**Historical Architectural Review Board
COA Final Review Sheet**

HDC-2023-00065

Address: 614 N. 5th Street

Proposal: Replace wood porch columns with fiberglass columns; infill opening

**Porch column to be replaced, 2023.
(Applicant)**

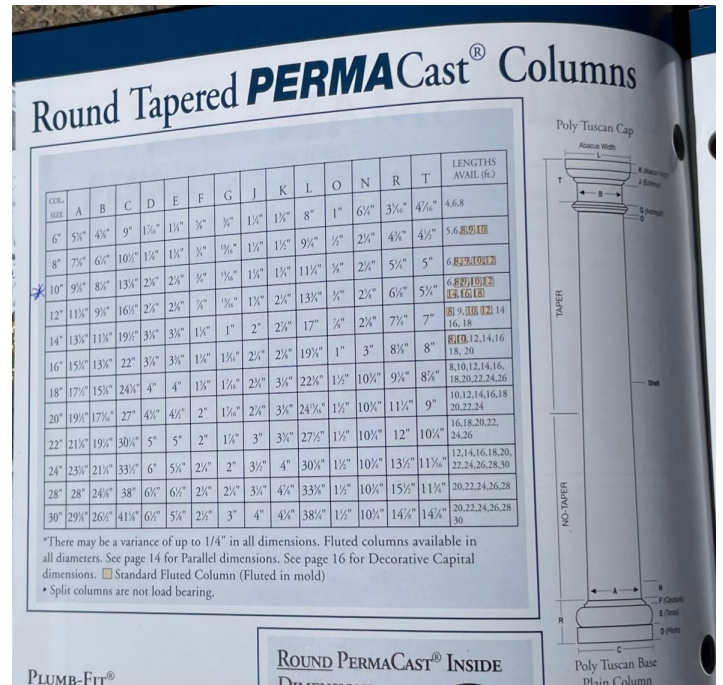
Building Standards has inspected the property and determined that two porch columns are rotted and require replacement. The owner has provided staff with specs on matching columns in fiberglass (PermaCast) and wood. The owner noted that the wood columns are hollow, though loadbearing, and that he prefers the fiberglass columns. The proposed columns have a tapered shaft and matching components. While a material change, they would replicate the appearance of the historic. Staff finds that the columns do not comply with Guideline 3.7.4 because of the material change, but do comply with Guideline 3.7.8. Despite the material change, staff finds the proposed alternative to be compatible and acceptable.

The application also proposes to legalize an infilled second-story window along the Page Street façade, though no details have been provided. Staff considers the Page Street elevation to be a contributing secondary façade and should comply with the guidelines, which recommend against infilling openings. The owner has noted in conversation with the staff that a shower exists behind the window, and that it cannot be reopened. In conversation, the owner has suggested infilling the window with brick veneer. Because infilling the window with brick would not comply with Guidelines 3.5.10 or 3.5.11, staff suggests that a fixed double-hung sash window with opaque glass (e.g., spandrel glass) be considered to better maintain the appearance of the window and ratio of openings.

Approval of the replacement of the wood porch columns with fiberglass columns, pursuant to Chapter 3, Section 3.7 Porches & Steps, but denial of the infilling of the window with brick veneer, pursuant to Chapter 3, Section 3.5 Windows.

The HARB discussed and agreed that the materials and appearance of the proposed fiberglass columns were appropriate. Ms. Keller then suggested spandrel glass be used to replace the glazing of the second story rear window so the window unit would not have to be replaced. Mr. Huber suggested an alternative option of inserting a wood panel behind the glass and painting it a dark gray color to give a background to the glass.

Mr. Lichtenwalner moved to approve with conditions the application presented on 10/2/2023 to replace wood porch columns with fiberglass columns and to reinstall window sashes at an infilled second-story opening, pursuant to Chapter 3, Section 3.5 Windows and Section 3.7 Porches & Steps, provided that the reinstalled window sashes have either spandrel glass or a painted panel behind the window. Mr. Huber seconded the motion, which carried with unanimous support.
